SUMMARY OF ITEM: Take all appropriate action to approve Change Order No.1 in the amount of \$7,269.32 (decrease) regarding Voss Road Phase II (from Old Richmond Road to SH6), Mobility Bond Project #48, Precinct 4. (Fund: Mobility Bonds) PC04300003654

CHANGE ORDER

PROJECT: Voss Road Phase II
 (name, address): from Old Richmond Rd. to SH6
 Bid #07-052

CHANGE ORDER NUMBER: 1
 DATE: 2/10/2009
 PROJECT NUMBER: 48
 CONTRACT FOR: 365 days
 CONTRACT DATE: 5/14/2007
 FBC PURCHASE ORDER NO. PC043-3654

VOSS ROAD
EXIST SAN SWR
AND PROP STM
SWR CROSSING

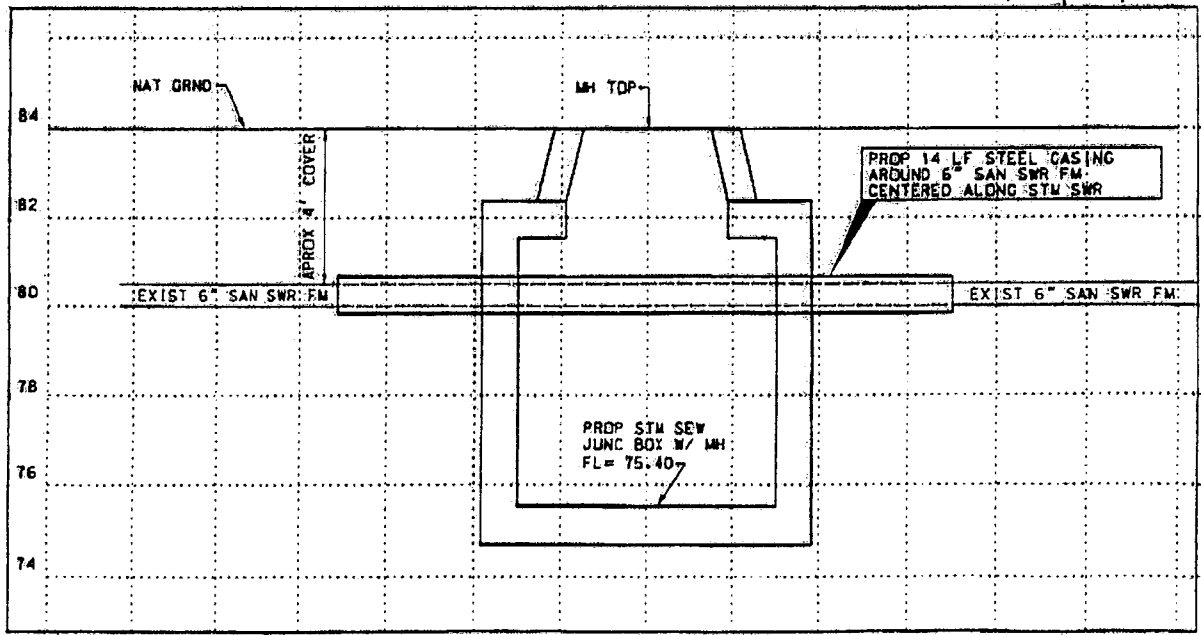
The contract is changed as follows:	Refer to Attachment			
1. ADD STEEL CASING AT MANHOLE AT STA.101+63	#1	LUMP SUM	\$	1,500.00
2. WATER LINE OFFSET 1	#2	LUMP SUM		1,950.00
3. INSTALLATION OF PVC PIPE AT SUGAR LAND CHURCH OF CHRIST	#3	LUMP SUM		6,691.62
4. ADJUSTMENT OF VARIOUS LINE ITEMS FOR OVER AND UNDER RUN QUANTITIES	#4	LUMP SUM		(17,411.00)

1. EXIST SAN SWR FM IS SHOWN AT APPROXIMATE HORIZONTAL AND VERTICAL LOCATION BASED ON FIELD MEASUREMENTS PROVIDED BY THE CONTRACTOR. CONTRACTOR SHALL ADJUST ACTUAL DIMENSIONS TO MEET FIELD CONDITIONS.
2. GROUT BETWEEN SAN SWR FM AND STEEL CASING WITH FLOWABLE FILL.
3. NOTIFY MUD OPERATOR PRIOR TO START OF CONSTRUCTION ACTIVITIES WITH THE SAN SWR FM AT THE FOLLOWING NUMBER: LARRY KELLER (281) 732-6614

COST PROPOSAL: LUMP SUM OF \$1,950.00

Attachment #2

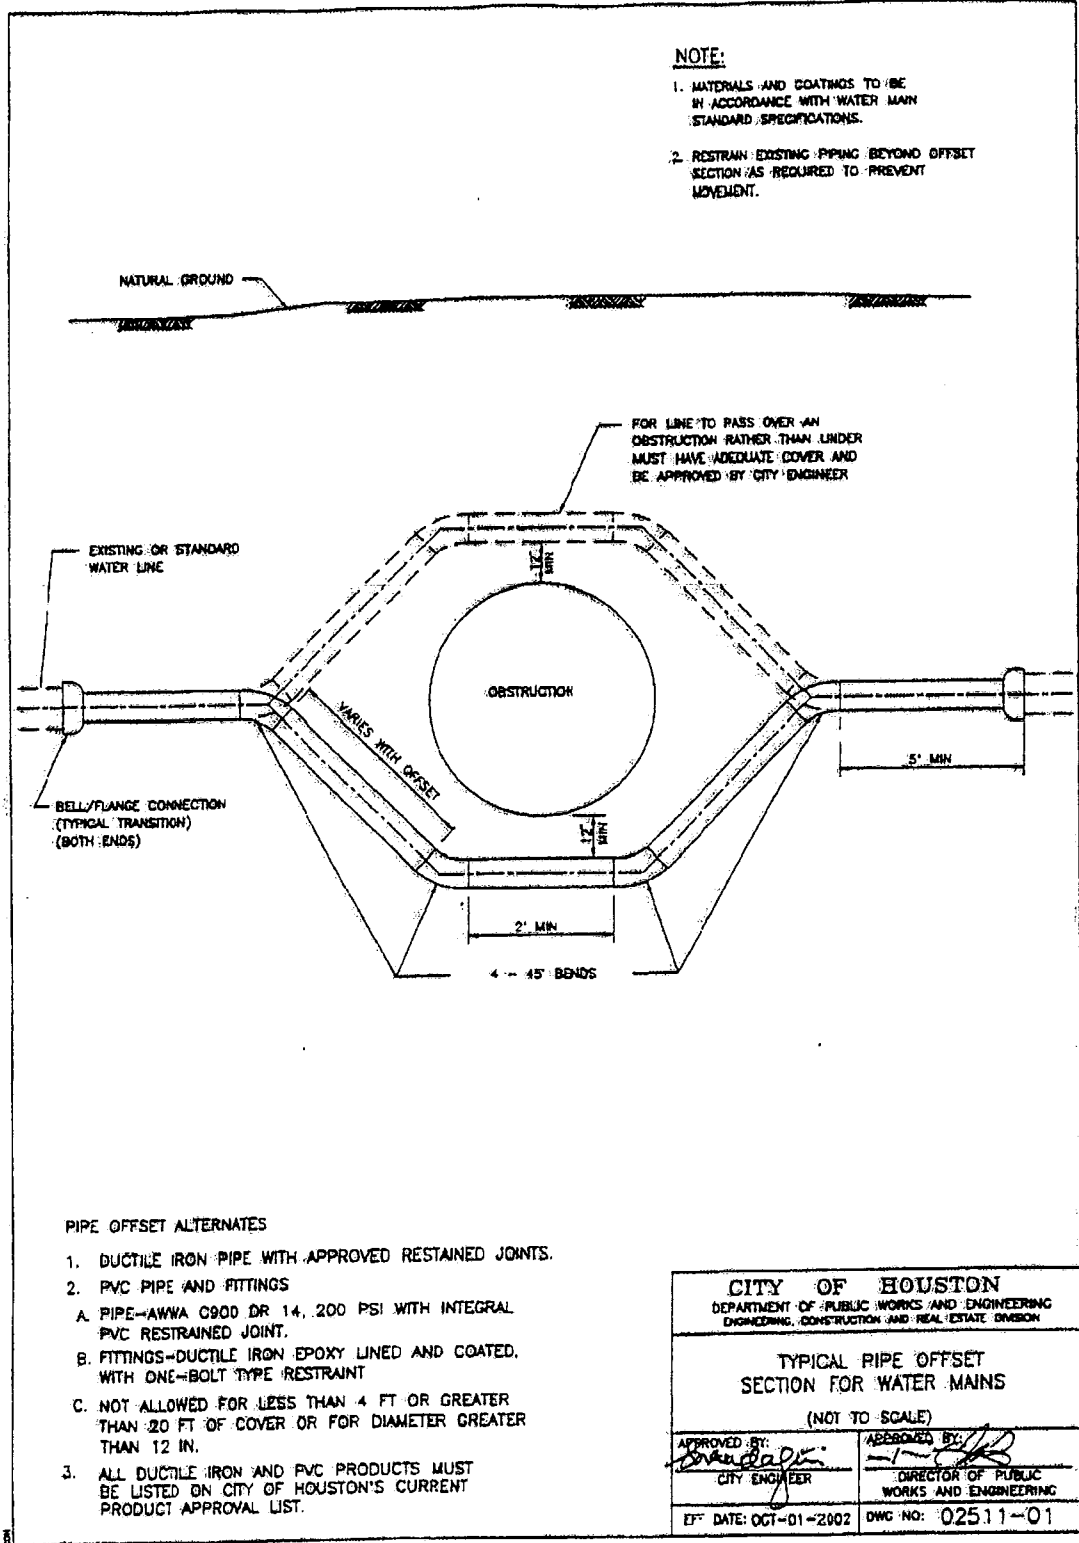
C.O. 3. Installation of PVC Pipe in front of the Sugar Land Church of Christ; this was necessary in order to provide drainage for the laterals that drain from the church parking lot. Please refer to the attached change order breakdown for this item.

COST PROPOSAL: LUMP SUM OF \$6,691.62
